TOWN OF BAY HARBOR ISLANDS
MORRIS N. BROAD COMMUNITY CENTER
1175 95TH STREET
BAY HARBOR ISLANDS, FL 33154

DEVELOPMENT & REVIEW COMMITTEE MEETING

Town of Bay Harbor Islands, FLORIDA
Design Review Committee
STAFF COMMENTS

PREPARED BY: Lorrainia Belle, Town Planner
ADDRESS: 9291- 9301 E Bay Harbor Drive
PROJECT# SPR26-000001
APPLICANT: Matthew Armster, Bercow Radell Ferndez Larkin & Tapanes

Date	11-26-2025	Sheet No.	A2.01.3
Scale			
Project	2567

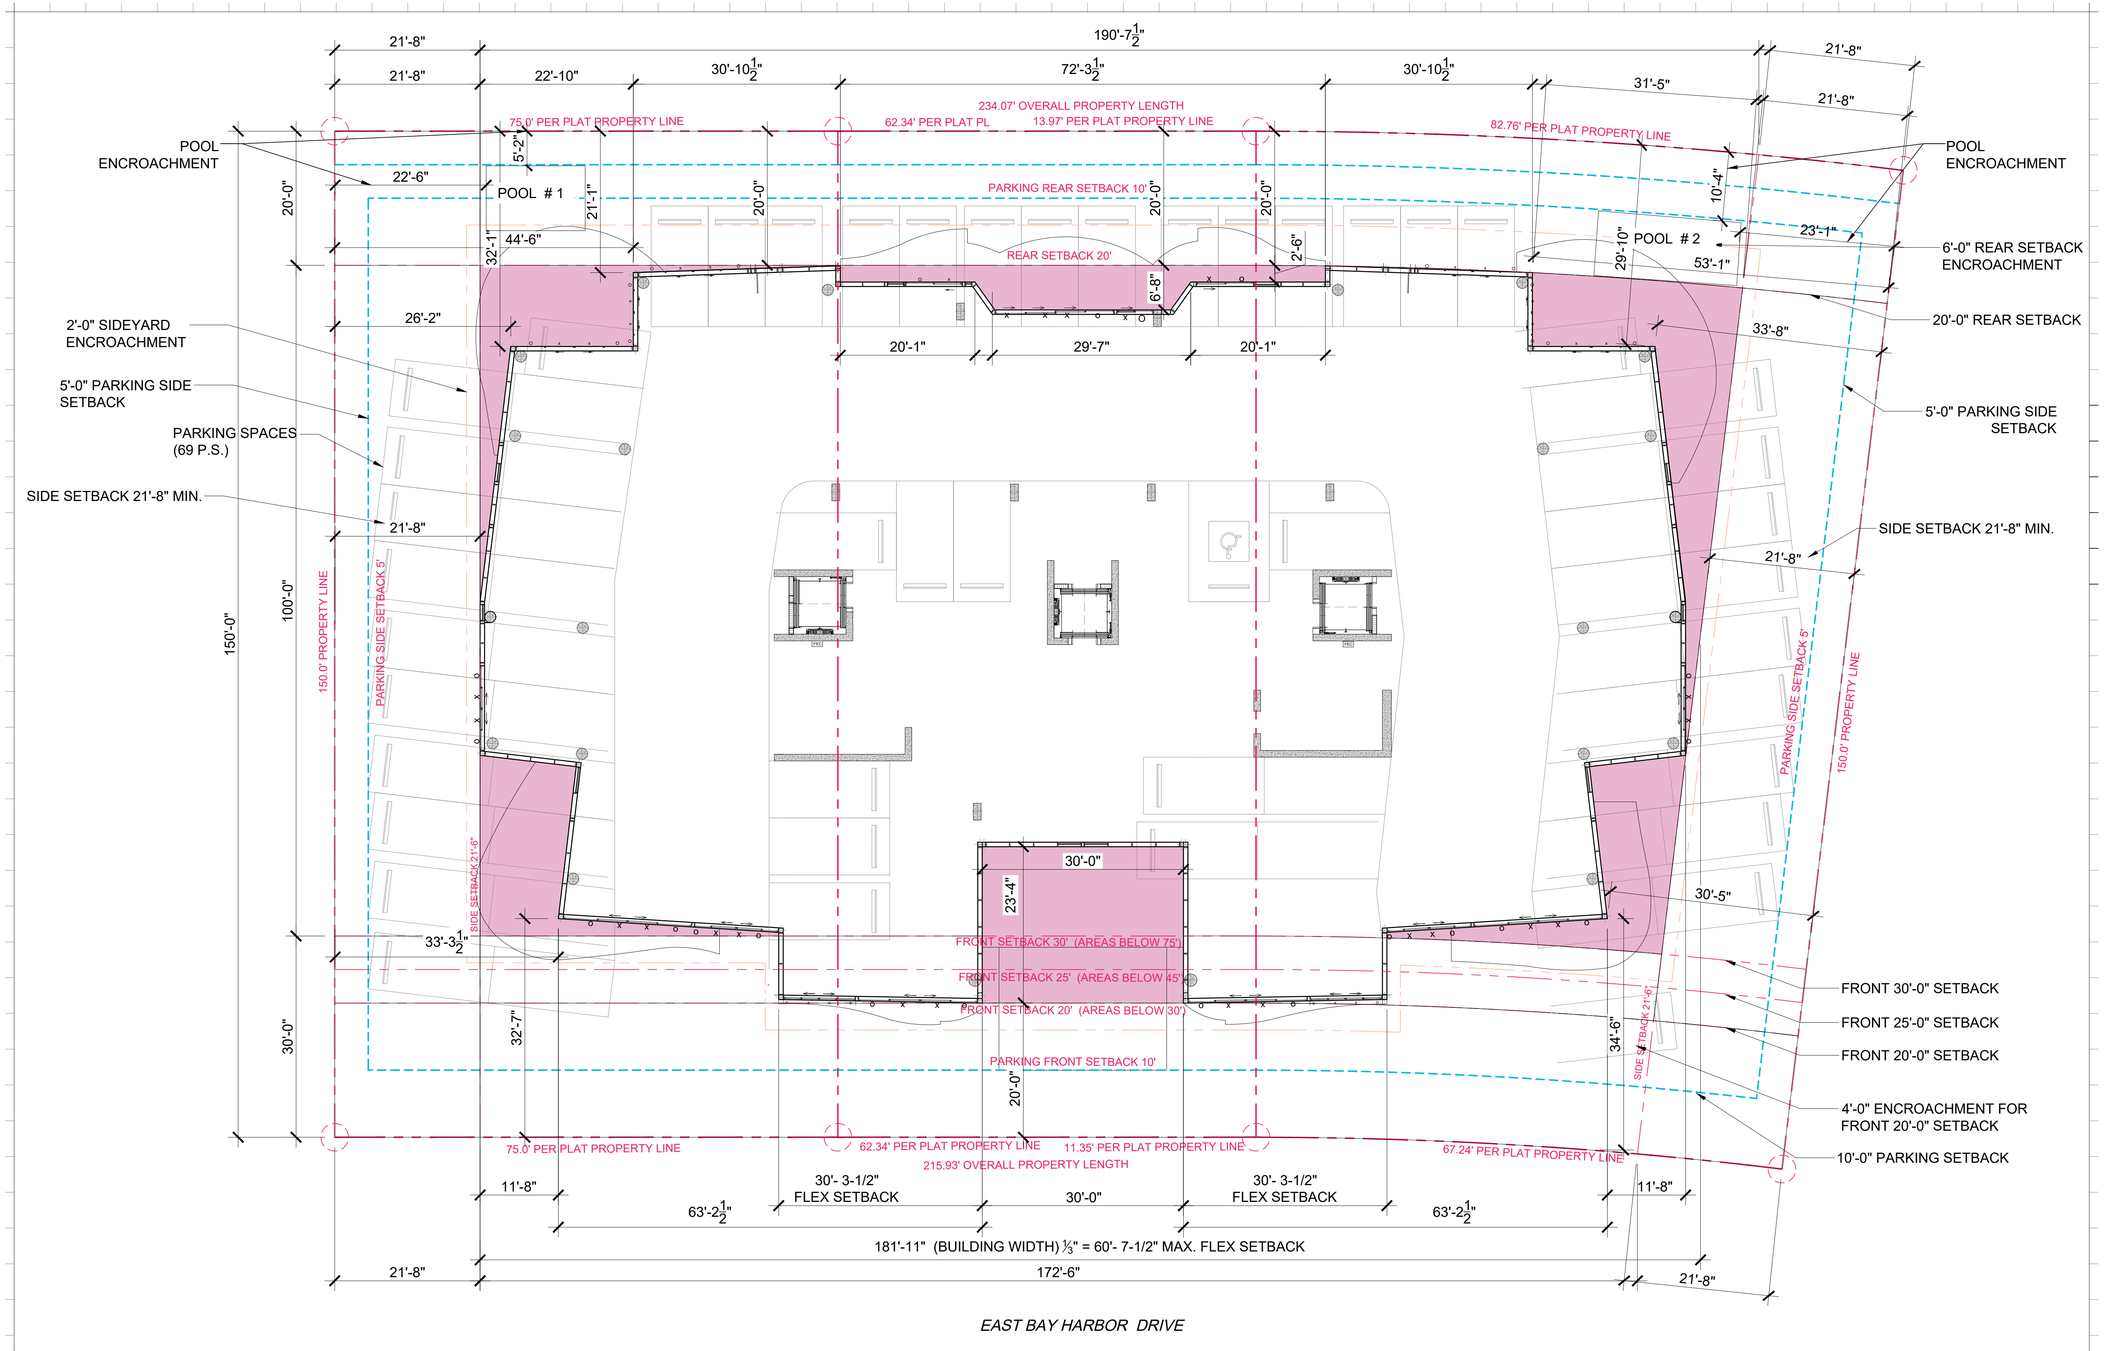
5. A2.01.3: Provide the total square footage of all push back zones and compare it to the required push back zone by the Code requirement.
6. A2.01.4: provide the square footage of the area.

Date	11-26-2025	Sheet No.	A2.02
Scale			
Project	2567

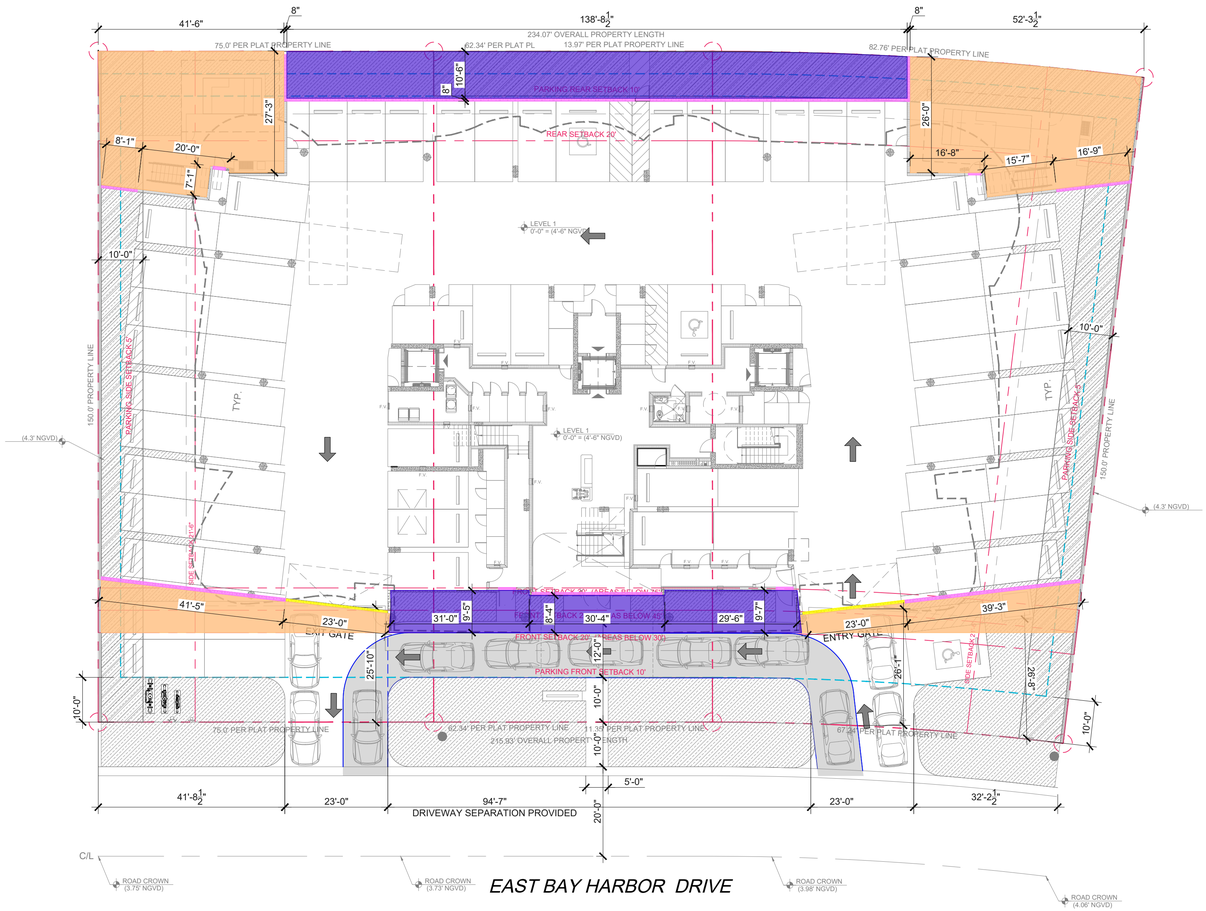
7. A2.02: How is this a modified breezeway when majority of the areas is within the setback requirement by Code?
8. Portico shown in the site plan is hard to read.

Date	11-26-2025	Sheet No.
Scale		A4.01
Project	2567

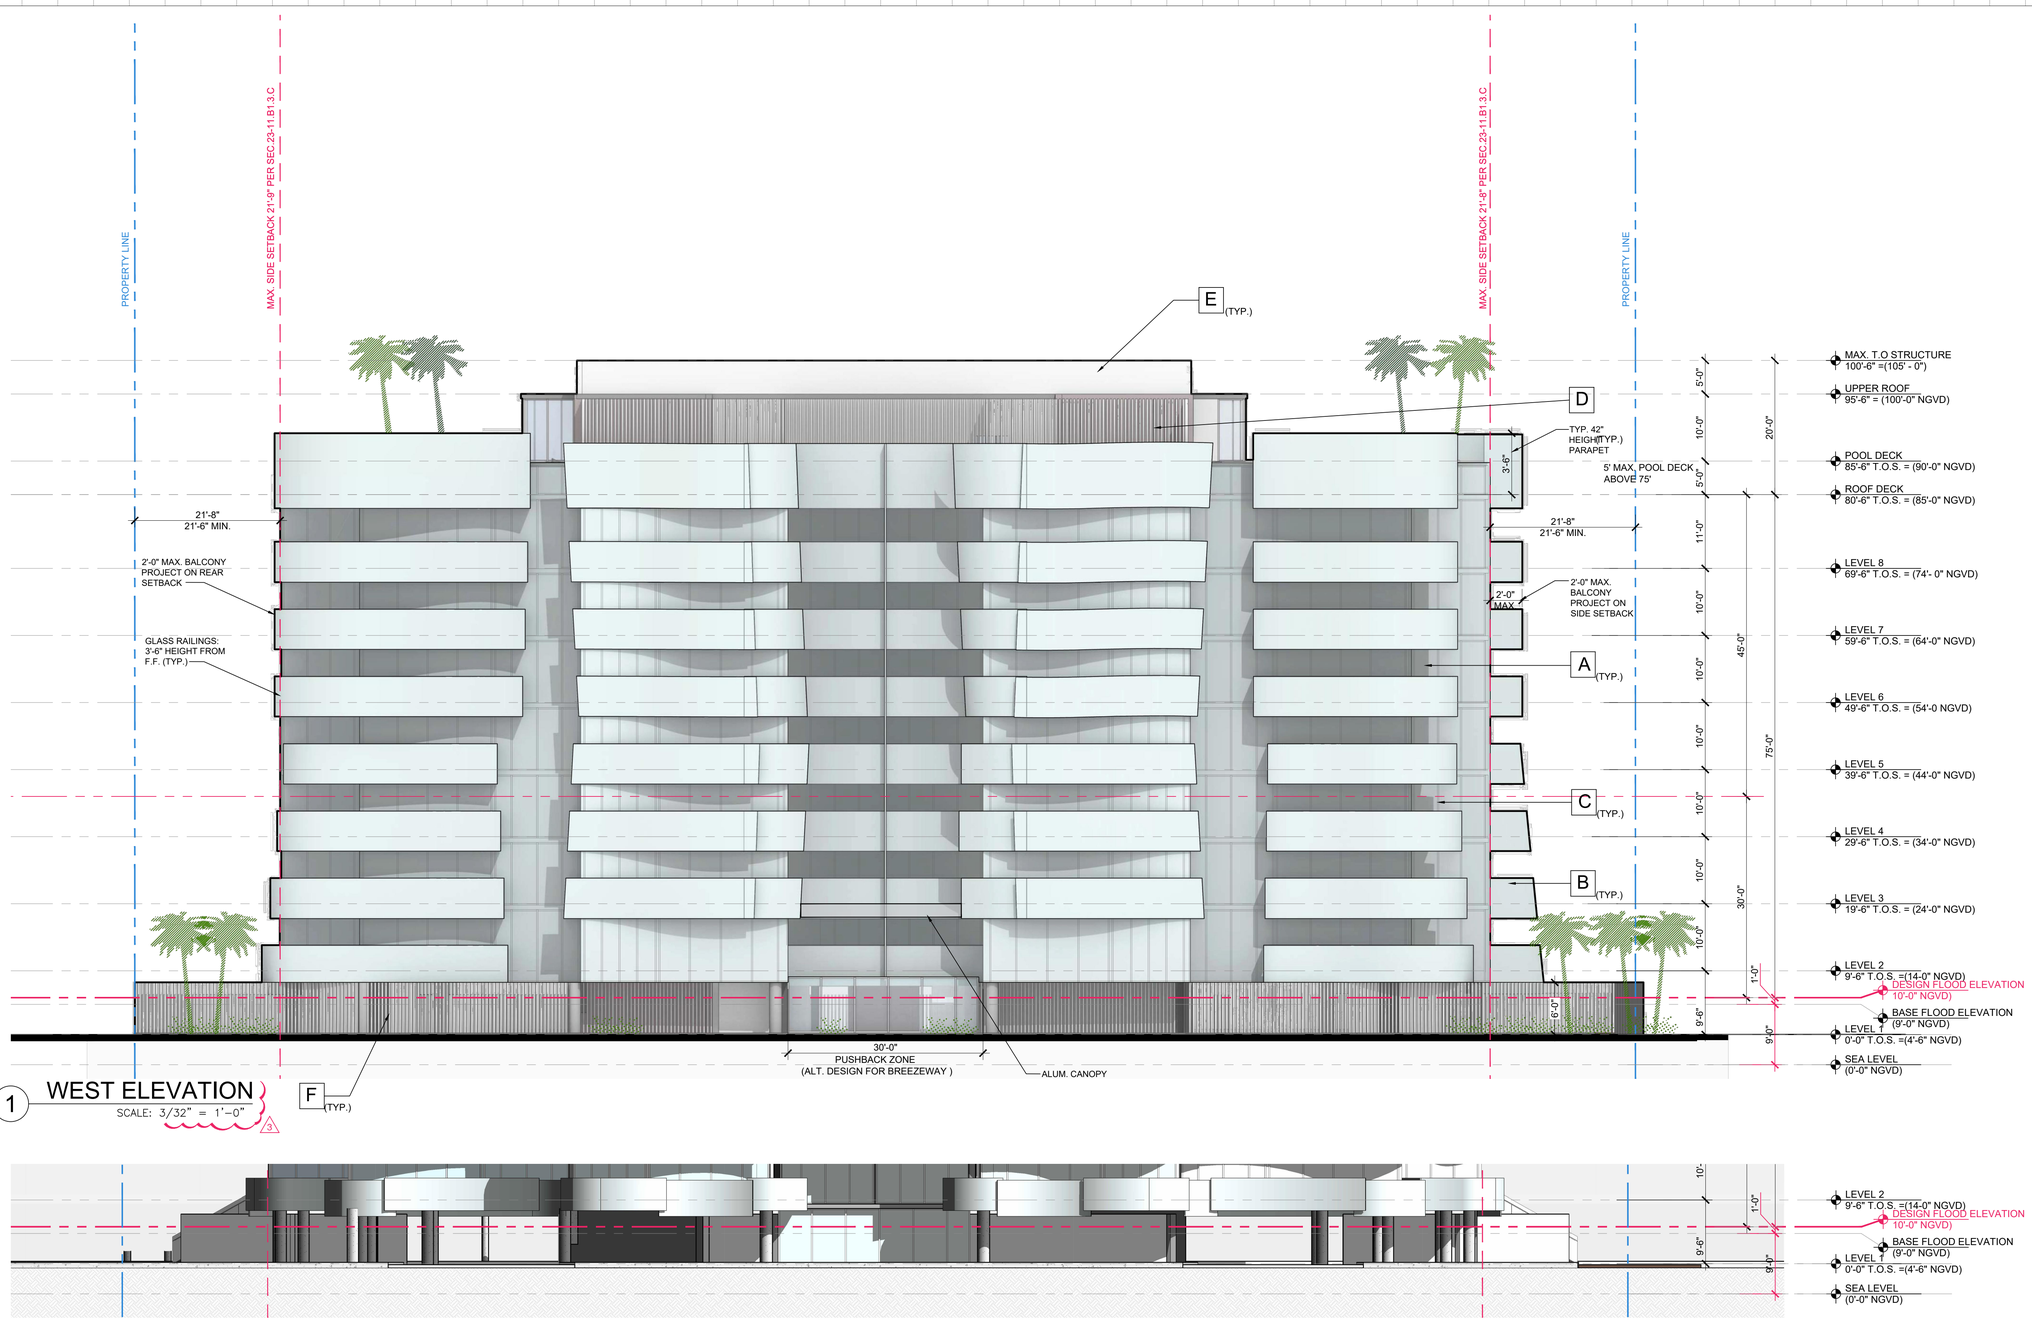
b. The partial image is still showing the 2nd floor balcony
15. A4.01: The West elevation (front)
    a. The floor plans proposal seems to mirror both side, but the elevation of both sides seems to be different. The floor plan needs to match the elevations.

b. Material D is stone but the image looks just like the fence, please fix it.
    c. Provide the setback for the rooftop structure from the edge.
16. A4.04 &4.05:

Date	11-26-2025	Sheet No.	A5.00
Scale			
Project	2567

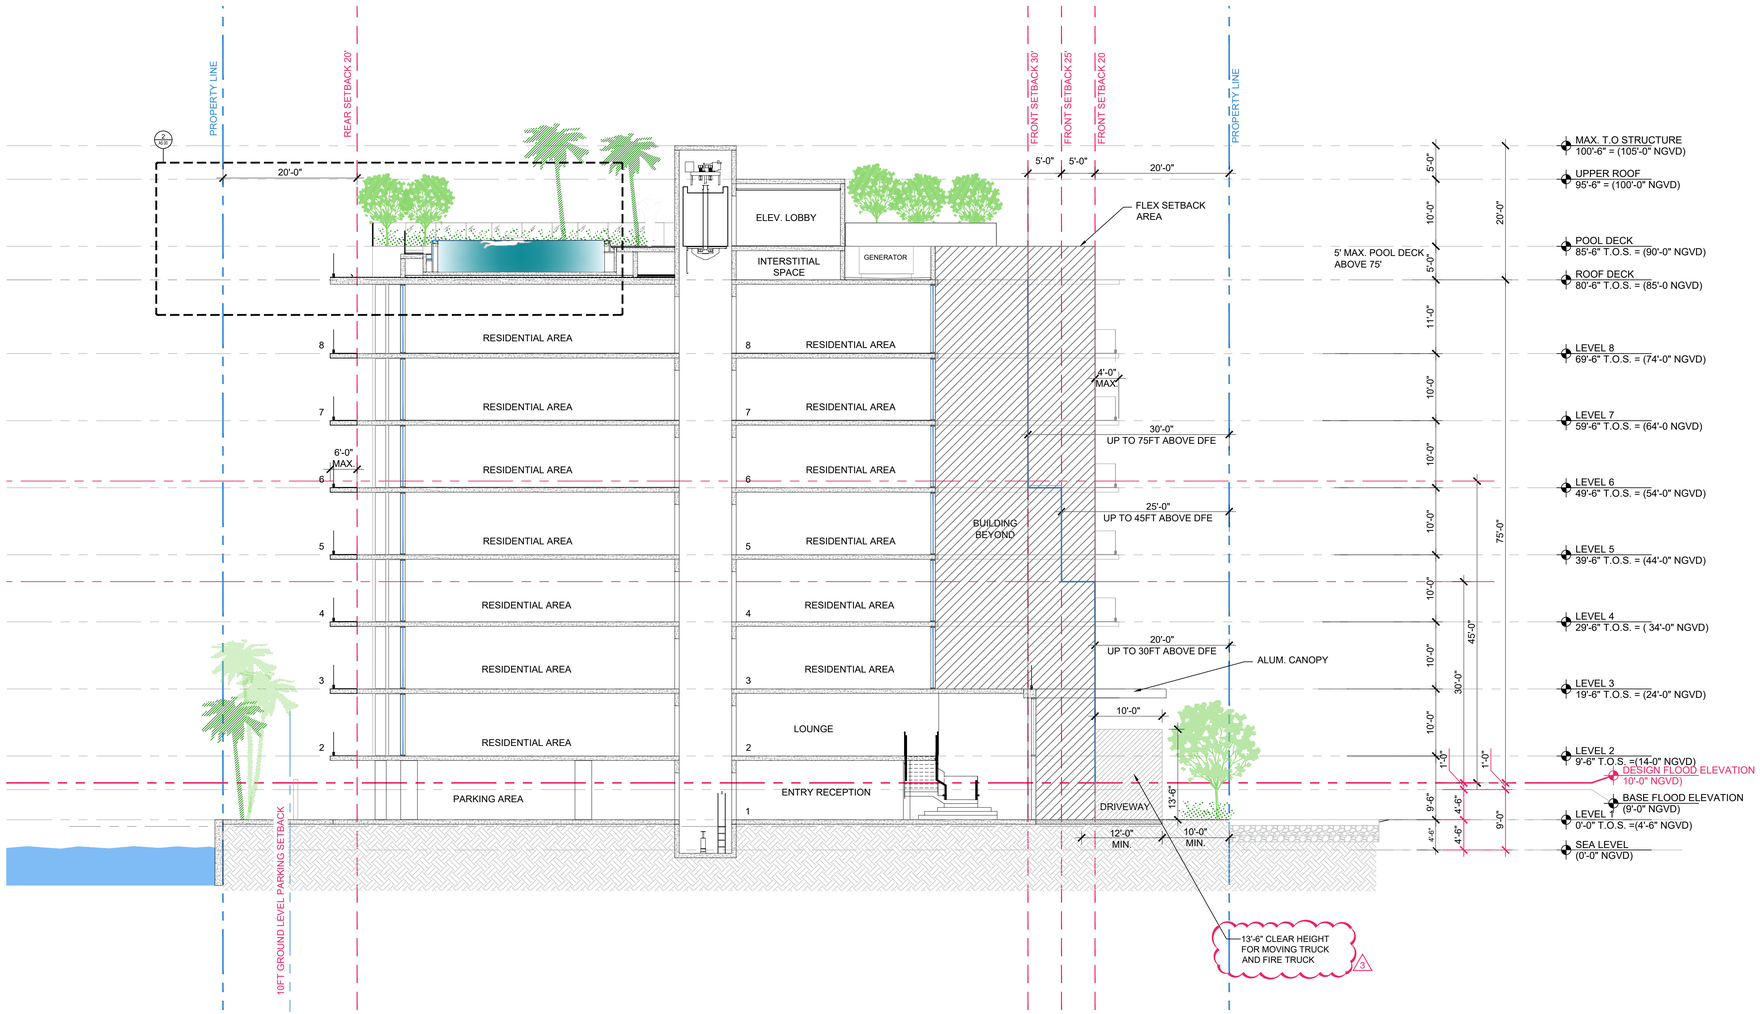
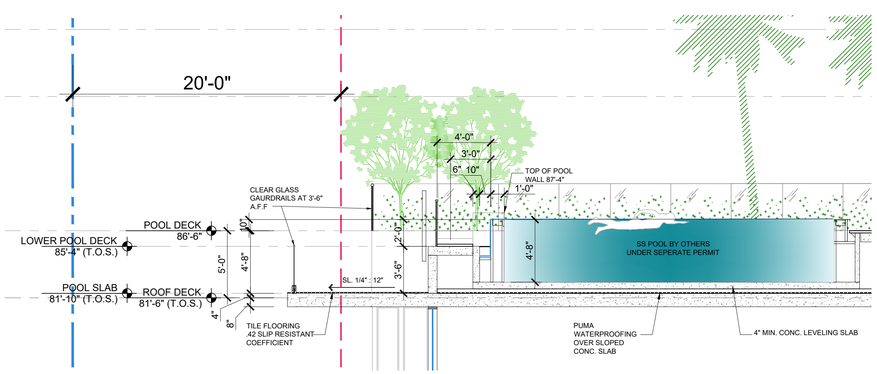
18. A5.00:
    a. The pool is showing over the 5 feet that is required by Code
    b. The wall that is being proposed, please label it on the rooftop floor plan
